UNITED STATES PATENT AND TRADEMARK OFFICE

APPLICATION NO.	FILING DATE	FIRST NAMED INVENTOR	ATTORNEY DOCKET NO.	CONFIRMATION NO.
10/705,680	11/10/2003	Hyeong-Geun An	5649-1197	4655
20792	7590	10/03/2005	EXAMINER	
MYERS BIGEL SIBLEY & SAJOVEC			TRAN, LONG K	
PO BOX 37428			ART UNIT	
RALEIGH, NC 27627			PAPER NUMBER	
			2818

Office Action Summary

DETAILED ACTION

FIG. 2'

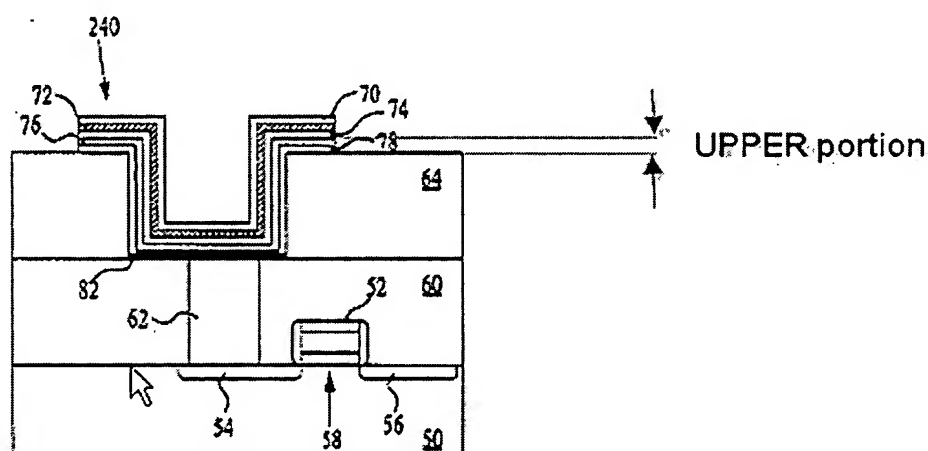
Regarding claim 3, Agarwal discloses the lower electrode 76/78 includes an UPPER portion (broadly interpreted; examiner's modified drawing fig. 2') thereof extending from the trench to a height relative to the integrated circuit substrate greater

than a height of the support insulating film and wherein the seed conductive film covers the upper portion of the lower electrode extending from the trench.
